Docket Item #'s 10 & 11  
BAR CASE #'s 2008-0040 & 0043

BAR Meeting  
April 16, 2008

**ISSUE:** New construction and waiver of HVAC rooftop screening requirement

**LOCATION:** 1309 King Street

**Figure 1: Proposed Front Elevation**

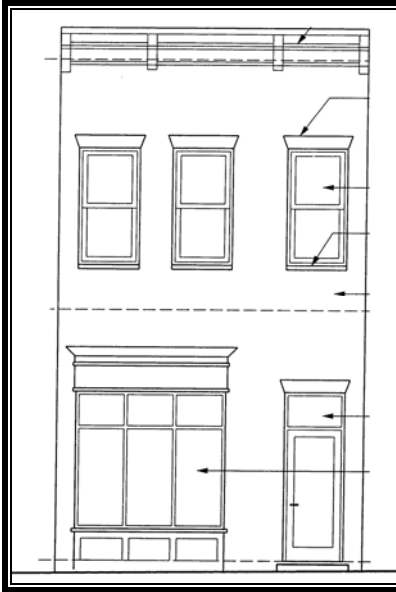
The proposed building is two stories in height and approximately 15' feet in width and 74' in length and will match the front building line along the blockface. The building will have an unpainted brick façade with a tri-partite bay window projecting approximately 20" with painted wood panels below, fypon trimwork and a single light wood door with transom on the first level. The second level will have three evenly spaced one-over-one clad wood double hung windows with brick sills and jack arches. It will be flat roofed with a decorative corbelled brick cornice with four brackets

The new building is essentially a replacement background structure. It is a quiet building that mimics the general retail shop fronts and fenestration found throughout the historic district. The new building while using more modern building materials for details is very traditional in the mode of 19<sup>th</sup> century commercial buildings found throughout downtowns around the country.

In the opinion of Staff, the materials, scale and historical details of the proposed new building are appropriate to the historic character of the King Street commercial corridor. The wood bay and transom windows are similar to the historic approach for the display of retail goods for many other building along King Street. The cornice line of the building effectively mediates between that of the three story building to the east and that of the two story building to the west. The overall character of the new building is similar to that approved by the Board for other new commercial buildings along King Street in the last few years such as just to the west at 1303.

Staff recommends approval of the applications with the following conditions:
